**SITE ASSESSMENT
FOR
ADA COMPLIANCE**

**Red Hill Sports Complex
Shaw Drive
San Anselmo**

January 18, 2022

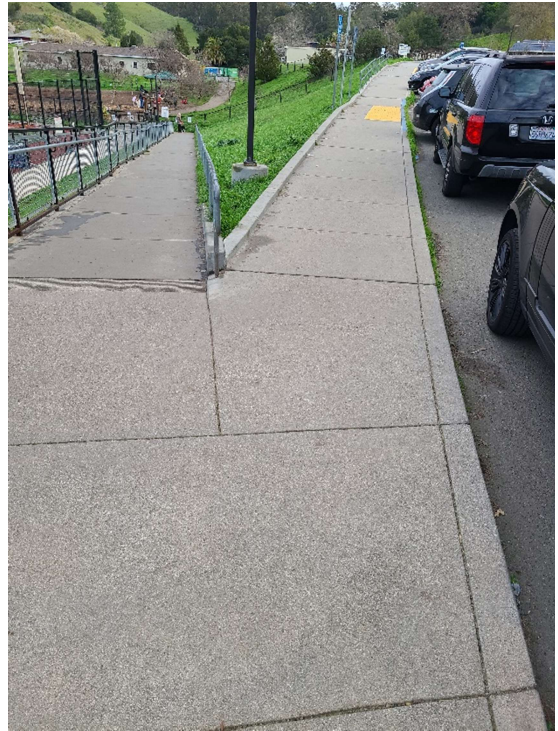
2. In the parking area on the northwest side of the park on Sunny Hills Drive the van accessible parking stall's signage is non-compliant, update signage on this parking stall. Otherwise, the depth of the stalls, striping and slopes are all in compliance.

3. At the west end of the parking area on Sunny Hills Drive the retaining wall is failing. The subsequent subsidence has caused the cross slope of the pathway to become non-compliant. The cross slope at this point is 4%, a maximum cross slope of 2% is allowed, this section needs to be replaced.

4. At the west end of the parking area on Sunny Hills Drive there is a significant gap in the concrete that is a trip hazard and non-compliant. Any cracks or chips over $\frac{1}{4}$ " inch are not compliant with current ADA standards. This gap is at least 3" inches and needs to be fixed.

5. The entrance to the parking area is missing "tow away" signage regarding ADA parking stalls. Install a sign at the entrance to the parking area.

6. The top of the existing ramp at the west end of the athletic fields does not have a landing area. This section needs to be replaced to meet current standards. The downslope and cross-slope of the ramp are in compliance. The landing at the bottom of the ramp also is in compliance.

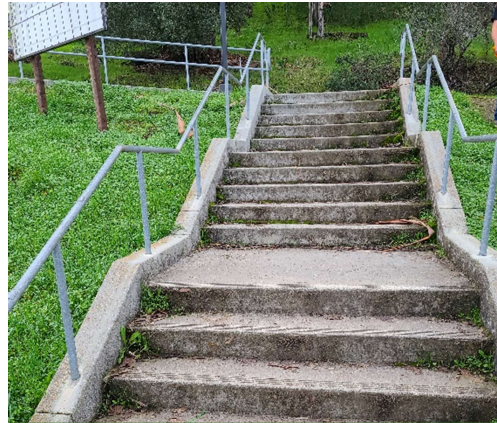
12. At the southeast end of the athletic fields there is a ramp up to the parking area on Shaw Drive. The downslope on a ramp with handrails can be no greater than 8.3%. This ramp has several areas where the downslope is greater than 8.3%, some areas are as much as 9.3%. The cross slope on the bottom landing and the first landing as you go up is greater than the allowable 2% maximum. When this ramp was installed the overall slope might have been in compliance but it appears some subsidence is occurring to change the ramp's slope. This ramp will need to be replaced to meet current standards.

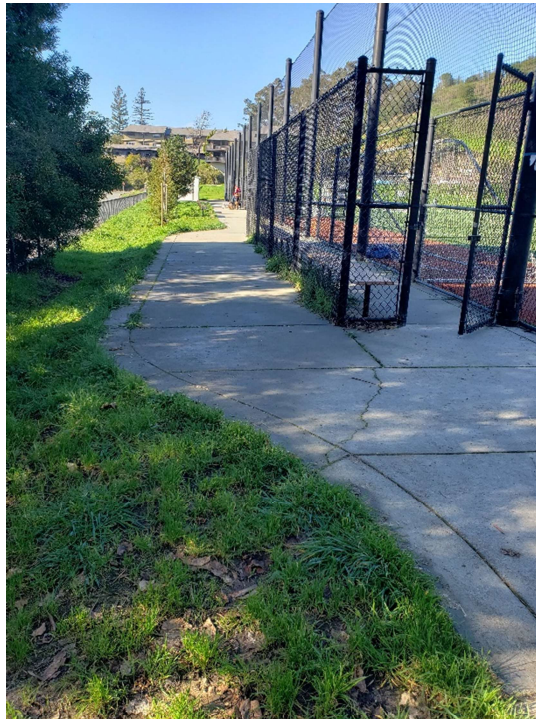
14. In the parking area on the southeast side of the park on Shaw Drive the van accessible parking stall's signage is non-compliant, update signage on this parking stall. The back side of the van accessible stall has a cross slope greater than 2% and will need to be fixed. The "tow-away" sign at this area needs to be moved to the entrance of the parking area. The non-van stall is compliant with depth, striping and slopes but the wheel stop at the front is missing and needs to be replaced.

15. At the west end of the parking area on Shaw Drive there is an accessible ramp that looks to be unused that is non-compliant. There should also be a cross walk installed from that ramp to the path of travel entering the sports complex.

16. The curb ramp at the entrance to the parking area on Shaw Drive has a cross-slope of 3.6% which is non-compliant and should be replaced. The stairs leading down into the sports complex are in generally good repair and are in compliance.

PH1.1

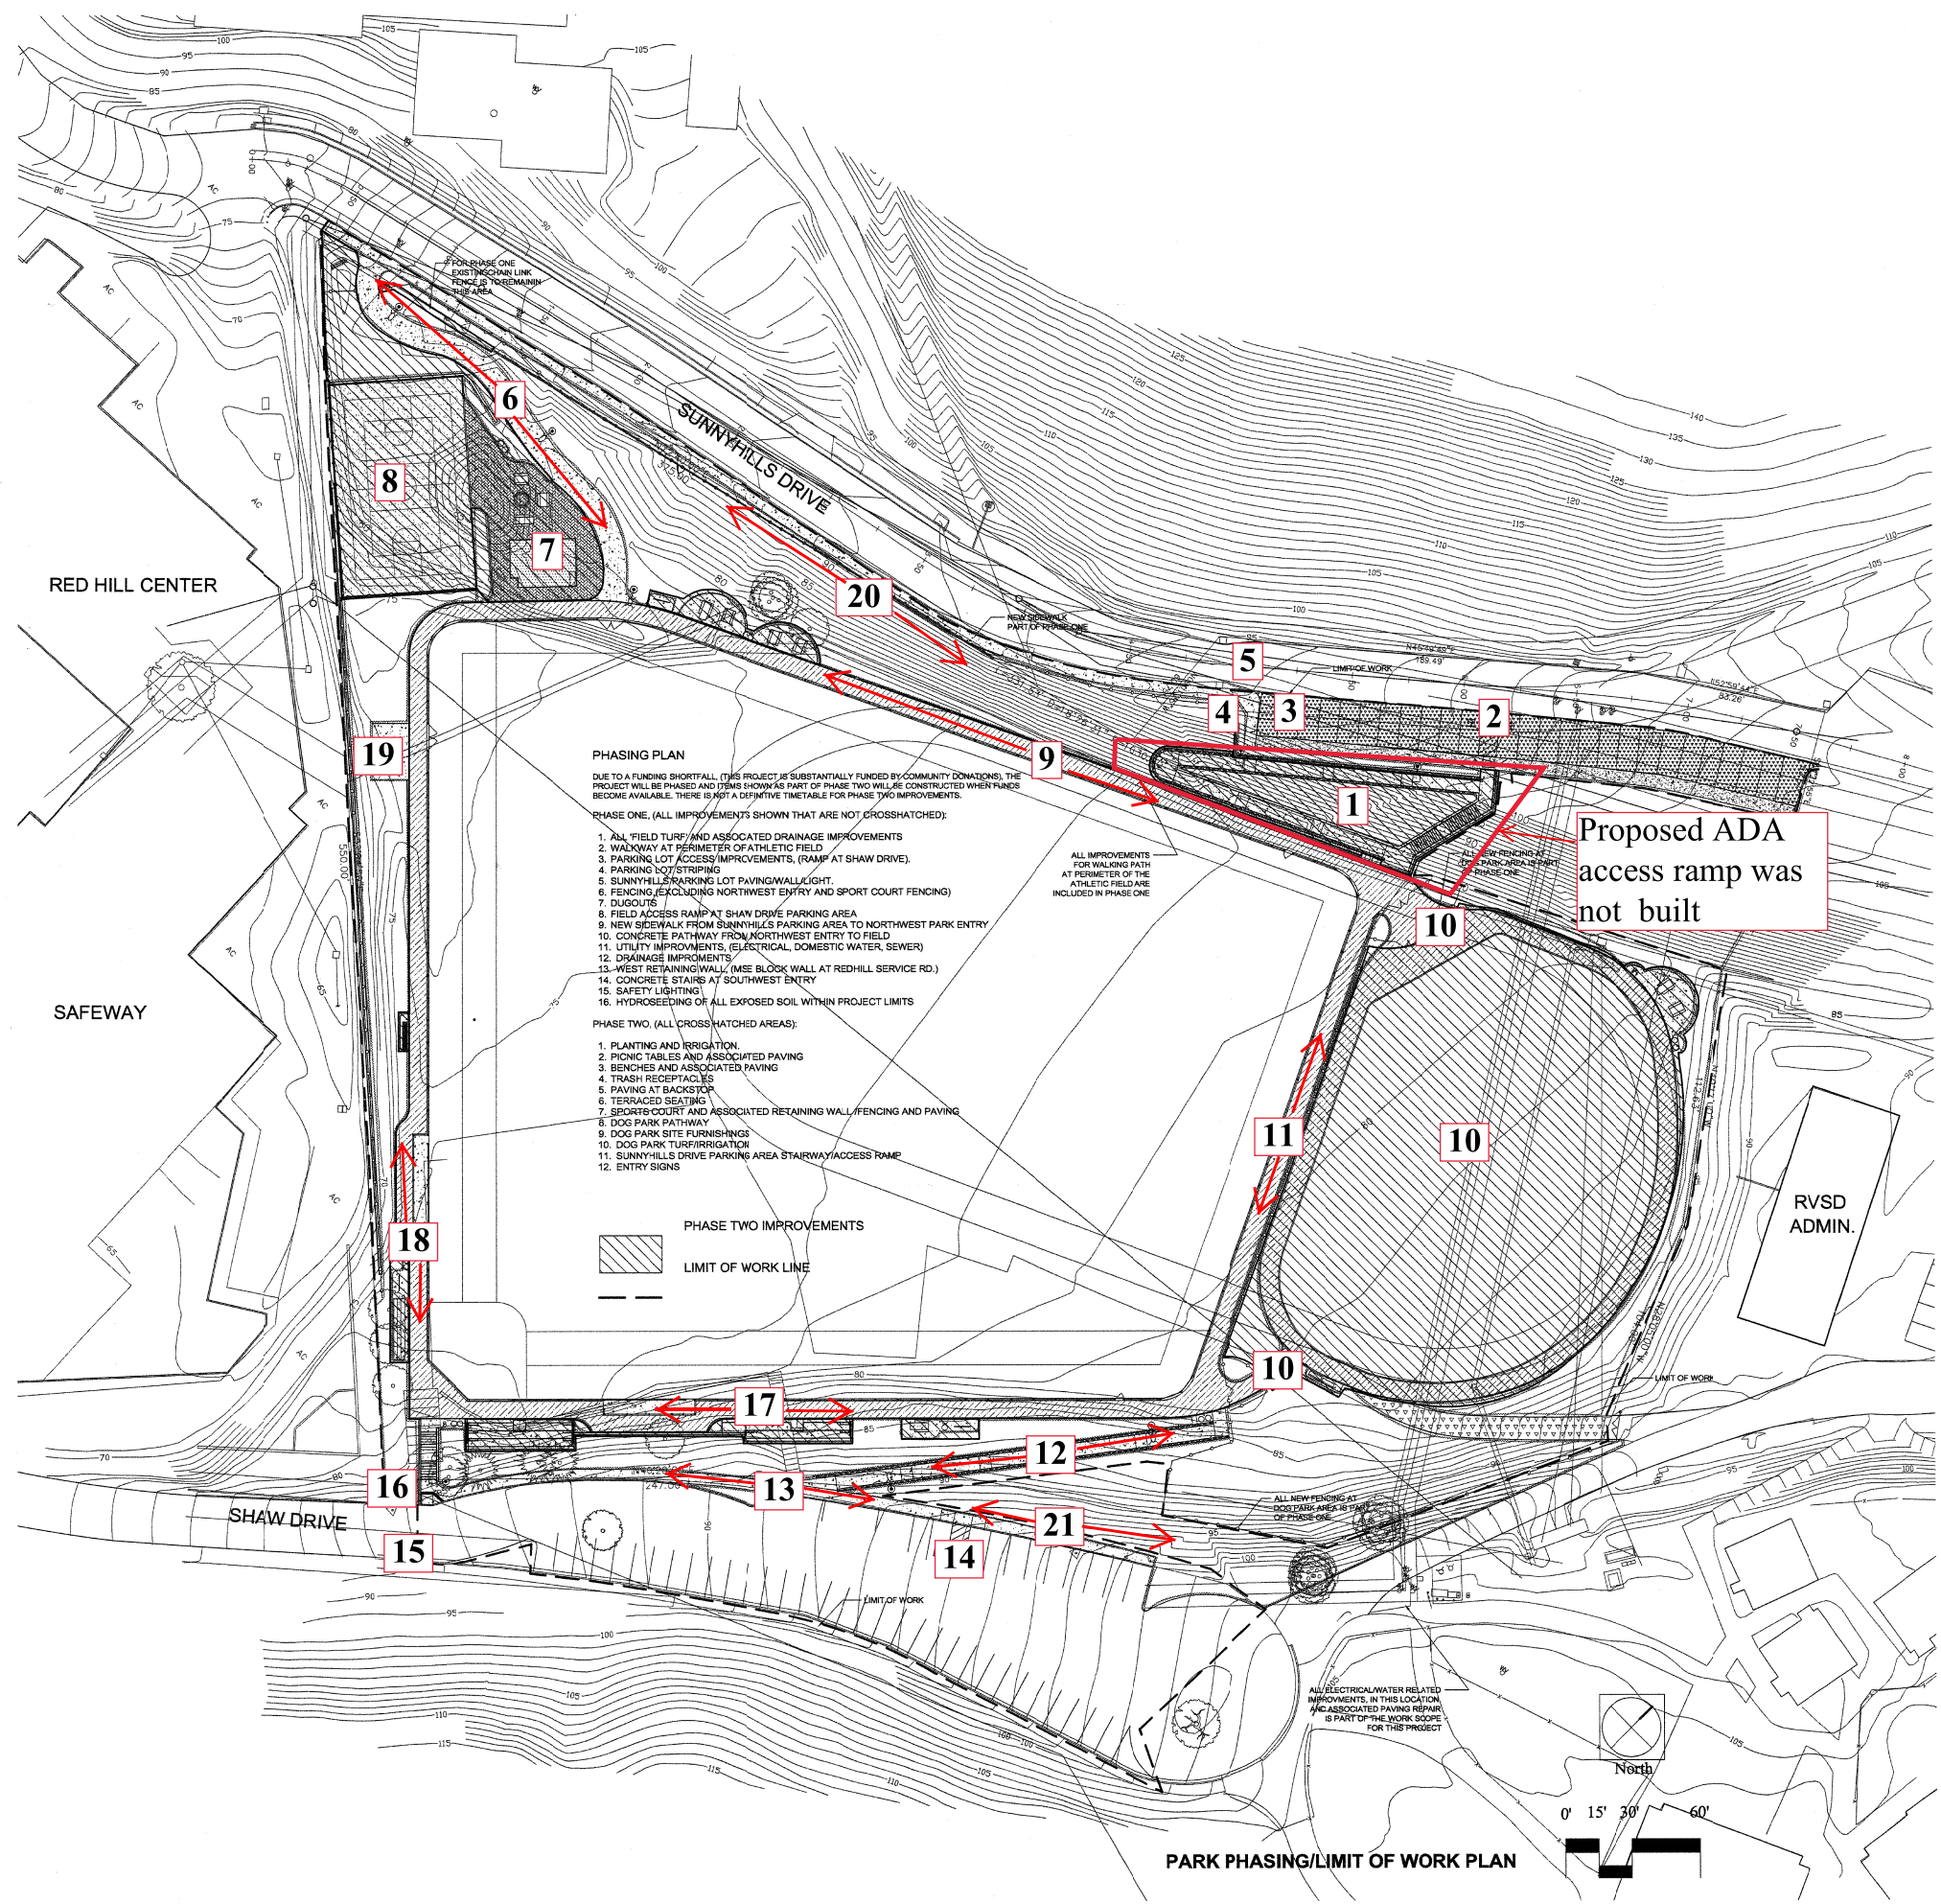
7. The proposed building was built without DSA permits and may need to be brought to current building codes.

8. The proposed basketball court was not built.

Proposed ADA
access ramp was
not built

General Safety Concerns

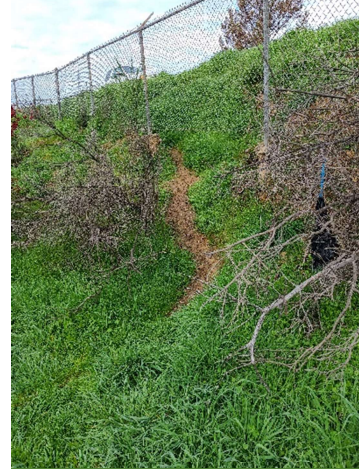
20. On Sunny Hills Drive there are three areas where people are avoiding the paths and entering the park in an unsafe manner. One area people are turning just past the end of the fence and connecting with the path of travel. The second area is an open gate in the fence where people are walking down a steep washed out grade down into the park. The third and possibly most dangerous, people are coming under the fence.

21. On Shaw Drive there are three areas where people are avoiding the paths and entering the park in an unsafe manner. One area at the dog park end of the facility people are coming straight down the hill and jumping the handrail of the ADA ramp. The second area people are climbing the short wall and walking straight down the hill. The third area people are walking down the hill instead of the stairs.
